MEMORANDUM

From:	Catherine Brimble Senior Landscape Officer
Service	WBC Landscape and Trees
App No:	241901
Address:	Barkham Farms, Barkham, Wokingham, Berkshire, RG40 4EX.
Proposal:	Application for submission of details to comply with the following conditions of planning consent 211081 dated 21.01.22 and NMA 241264 dated 08.07.24: Condition 5 (partial discharge) relates to landscaping details; 6 to landscape management; 7 to tree protection; 9 (partial discharge) to archaeological investigation, 10 (partial discharge) to rights of way details; 15 to landscape and ecological management plan; 16 to ecological permeability
Type of Development:	
Site Visit Made:	Yes/No

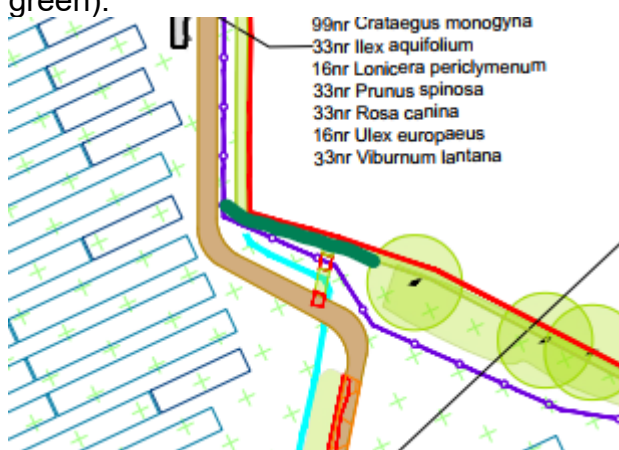
- An area of existing vegetation (G4 on Tree protection plan) on the south-eastern boundary of field 6 (see location below) is shown to be removed and will need to be replaced with new hedgerow planting (length identified in dark green).
